**BLOOMINGTON PLAN COMMISSION
STAFF REPORT
LOCATION: 3100 W. Fullerton Pike**

**CASE #: ZO-23-20
DATE: November 9, 2020**

Subject: ZO-23-20: Bill C. Brown Revocable Trust Rezone
3100 W. Fullerton Pike

3.) ROAD CONNECTION:

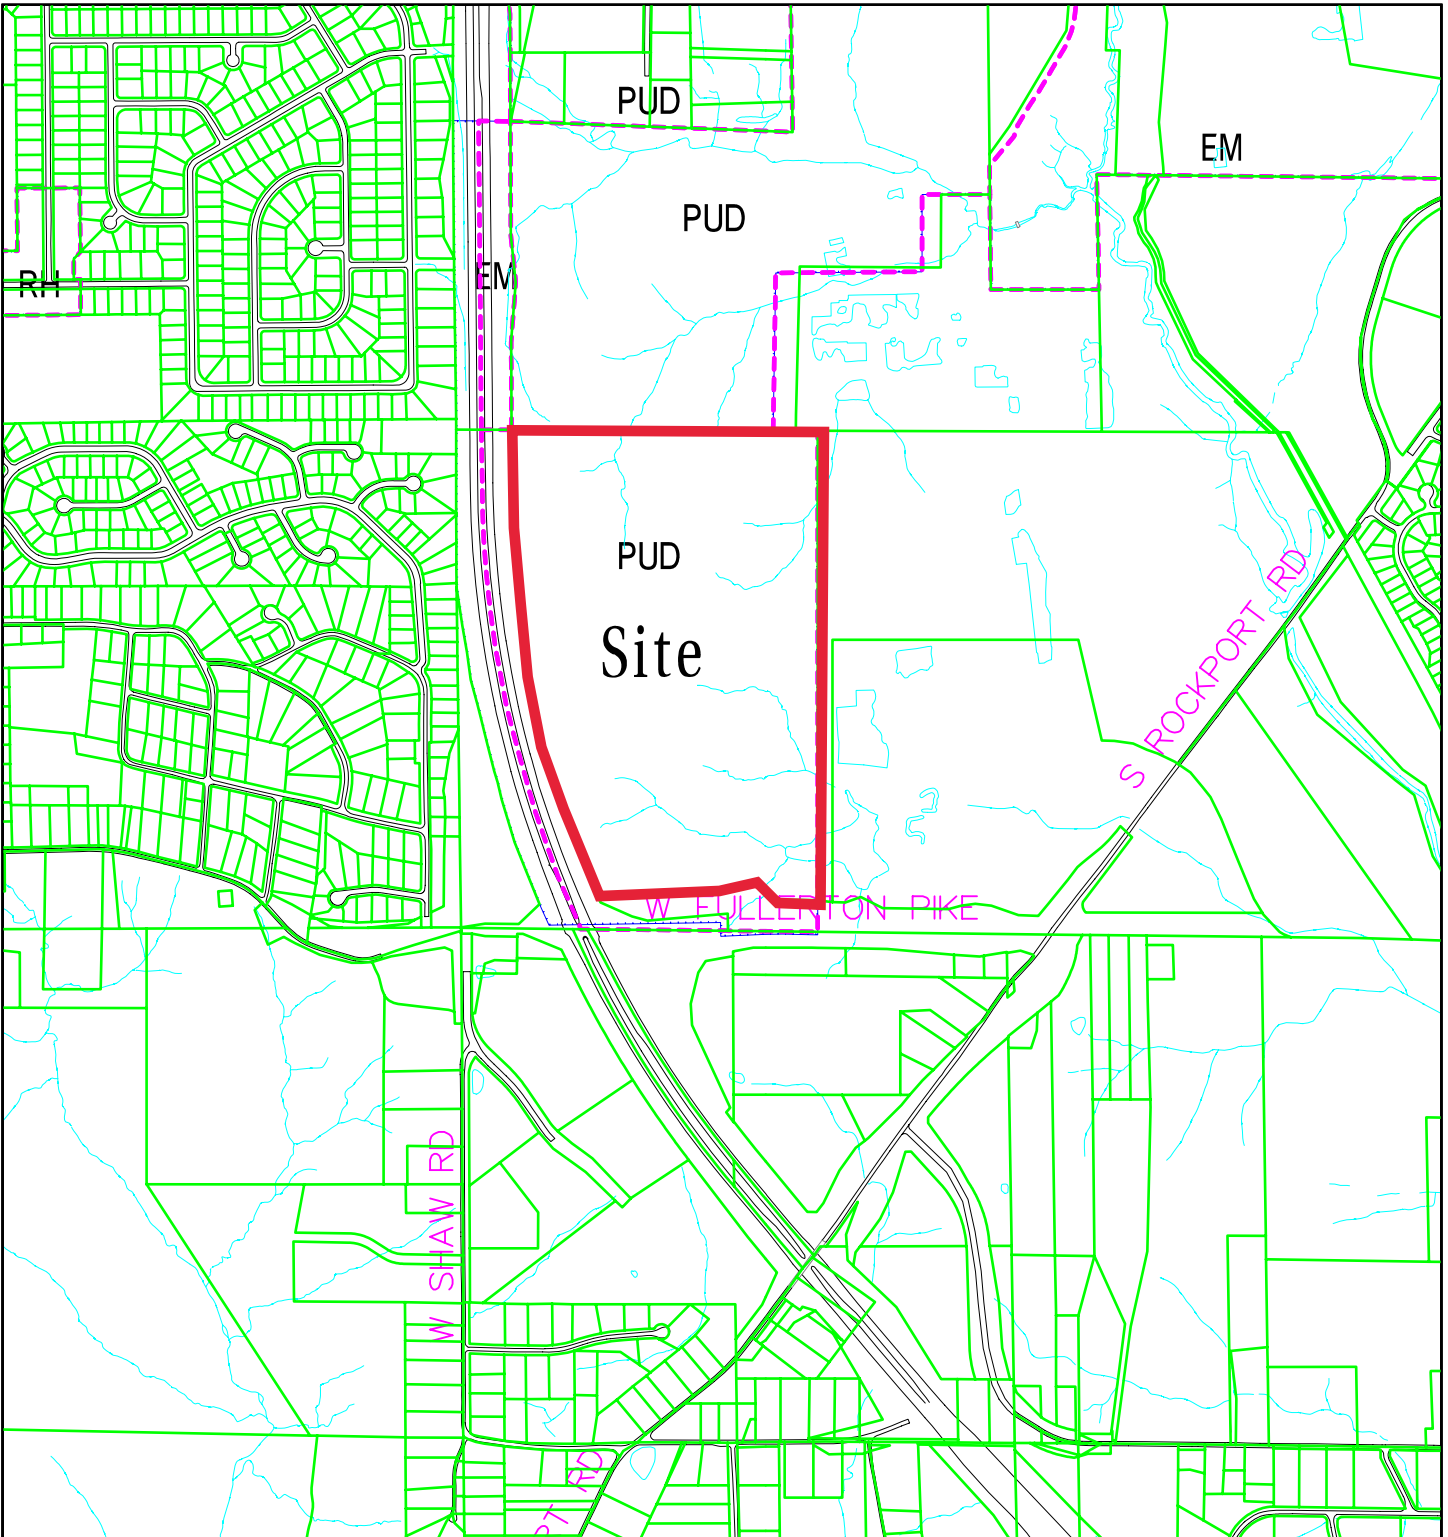
The EC is not in favor of the future road stubbing into the adjoining woods at the location shown on the plans. In the past, there was much discussion regarding saving the mature woodland to the north of this property. The EC would still recommend protecting that woods.
